NATIONAL TRANSPORTATION SAFETY BOARD

Airworthiness Directive (AD) 94-01-07
Boeing 737 Service Bulletin 737-27-1185
Boeing 737 Service Letter 737-SL-27-57
AD 94-01-07 Final Rule NPRM Comments
AD 80-07-02 Fortner Engineering Control Valve

94-01-07

**SUBJECT: FLIGHT CONTROLS - RUDDER AND TAB - RUDDER POWER CONTROL UNIT -
REPLACEMENT OF THE DUAL SERVO VALVE**

FIGURE 1. REPLACEMENT OF THE DUAL SERVO VALVE IN THE RUDDER PCU

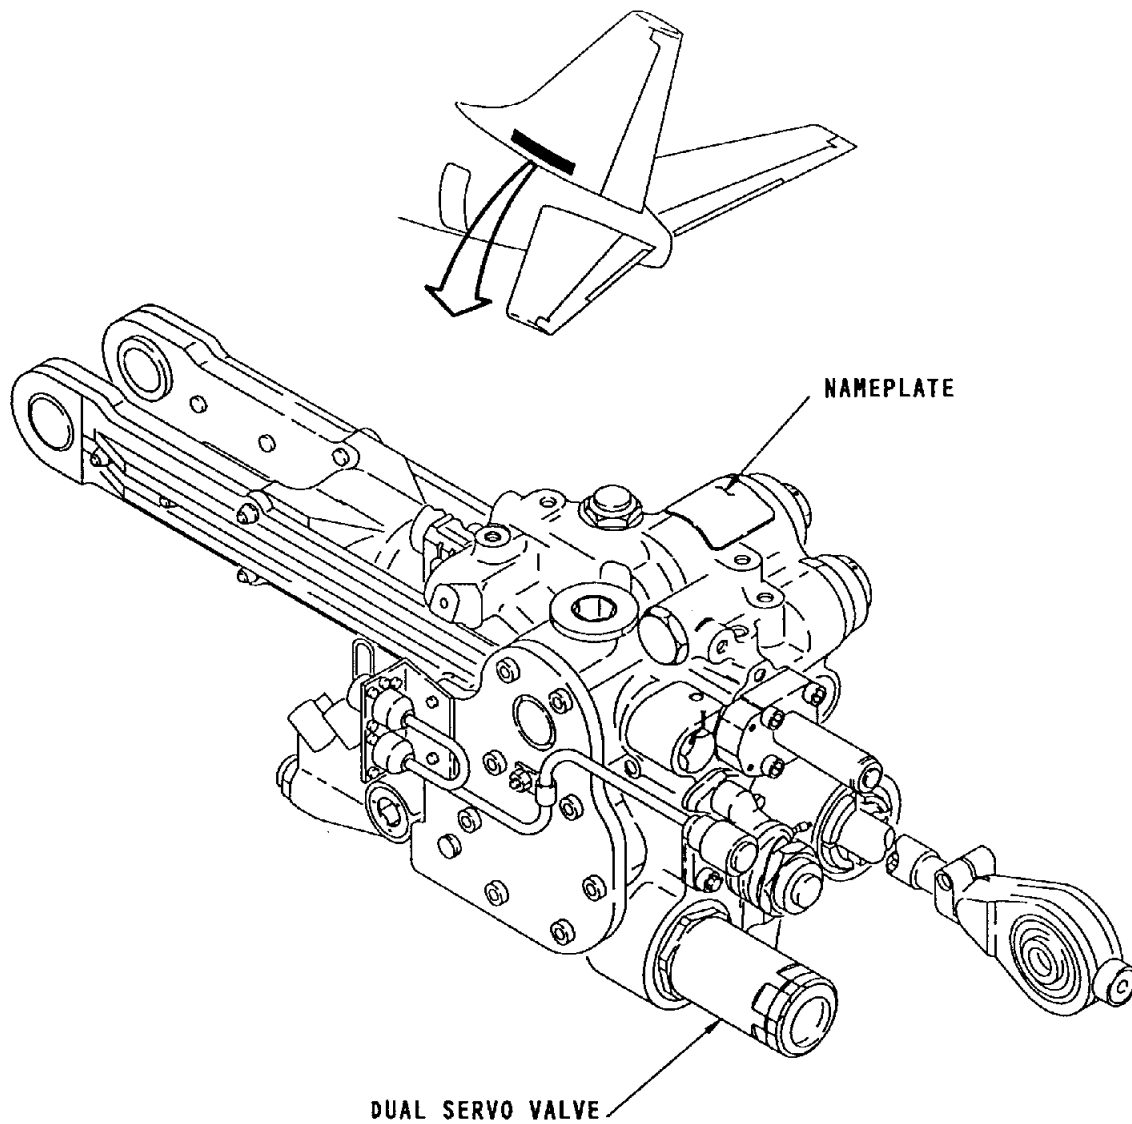
- A. Remove the dual servo valve 68010-5003. Refer to the Overhaul Manual 27-20-01.
- B. Install a new dual servo valve 68010-5005 or -5007. Refer to Overhaul Manual 27-20-01, with the March 1, 1993 (or later) Temporary Revision.
- C. Change the part number of the rudder PCU. See the table in Paragraph II.D., Existing Parts Accountability, for the new part number. Use a new nameplate BAC27DHY0358. Refer to Boeing Standard Overhaul Practices Manual 20-50-10.

- D. (This step is removed.)
- E. Do the hydraulic and operational tests of the rudder PCU. Refer to Overhaul Manual 27-20-01, with the March 1, 1993 (or later) Temporary Revision.
